Reading Conservation Area Advisory Committee
21 July 2024

COMMENTS ON APPLICATION 240661 REPLACEMENT OF FOLK HOUSE WINDOWS

Reading CAAC makes observations below on the proposal to replace timber sash windows with UPVC sash windows at the Folk House, Church Street, Reading.

Figure 1 Goad Insurance map 1895 extract showing Church Street. British Library via Wikimedia Commons

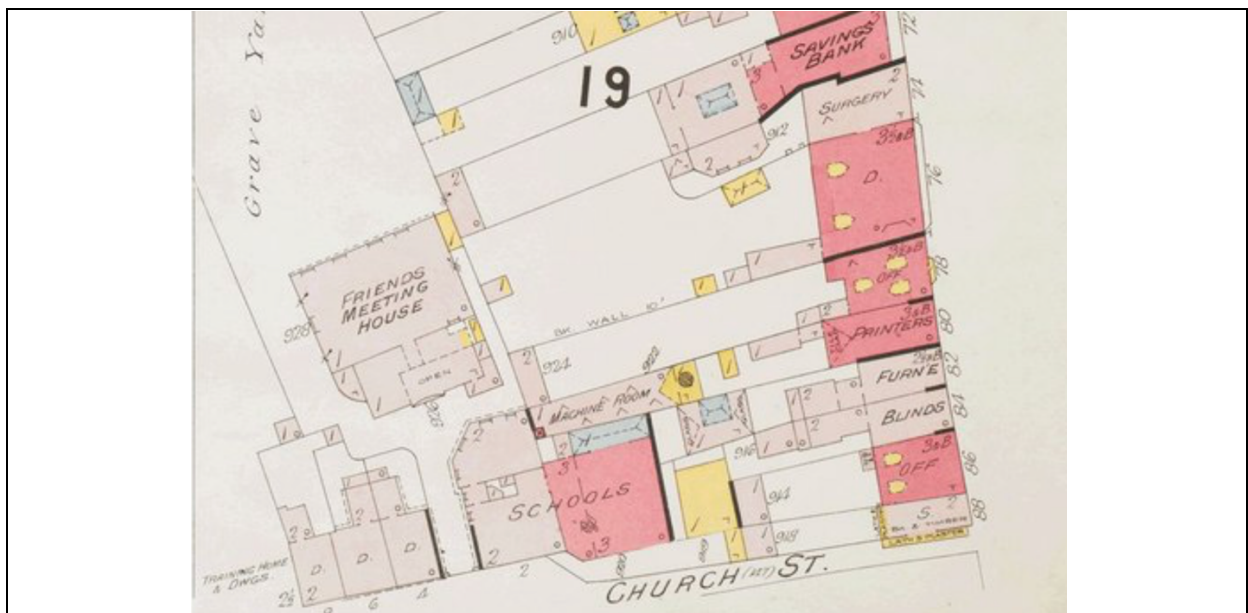
1.2 In addition to the historic maps submitted by the applicant, the Goad insurance map below from 1895 shows the building as being a 3 storeys tall brick building and marked 'SCHOOLS'.
